## C3 Asset Inventory

### Changes from the draft Business Plan

**WATER MAINS up to 320 mm DIAMETER**

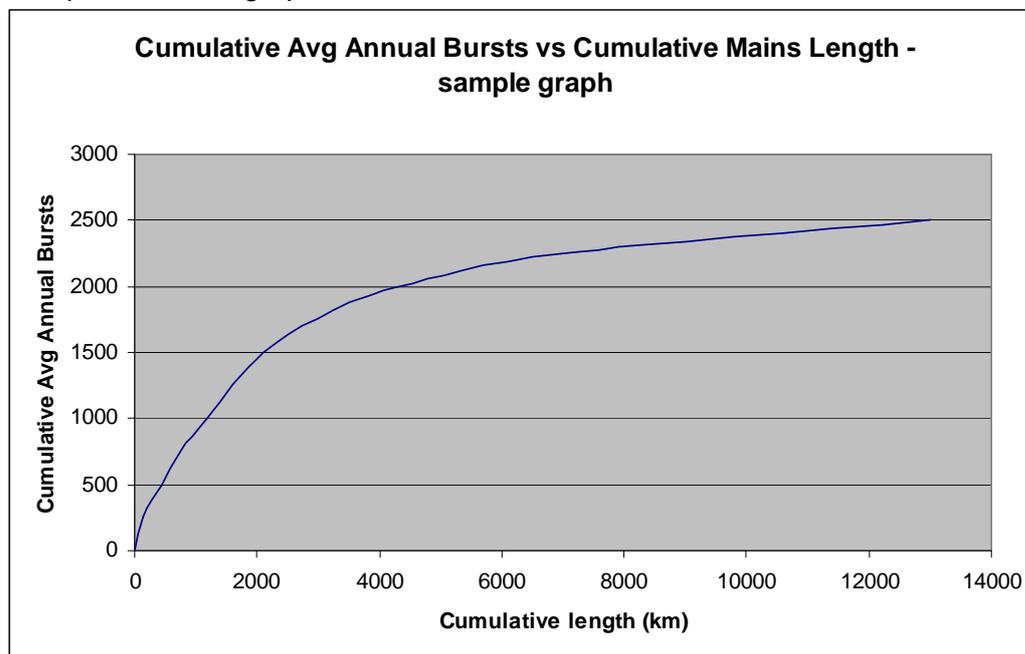
We can verify that the Company has provided this graph in its final Business Plan Part C3 commentary and can verify that the majority of data points are near the Y axis. The appearance of the graph implies that there are more data points to the right; however, this is not the case as it is due to superimposed data points within the first quartile and short lengths with few bursts in the upper decile. The Company has marked on the median point on its graph to demonstrate this effect.

The Company has reproduced the graph and it is now correct and demonstrates the data in the correct way. The median of all data points is now marked on the graph in the Company's commentary. The majority of the data points are close to the Y-axis although it may not appear so at first glance. This is because there are several cohorts of short lengths responsible for the majority of bursts and several superimposed points. There are also a number of cohorts with short lengths with very low burst frequencies to the right of the graph – this gives the impression that the majority of the data points are furthest away from the Y axis. We have audited the Company's graphs and data and verify that the graph does represent the data in line with the guidance.
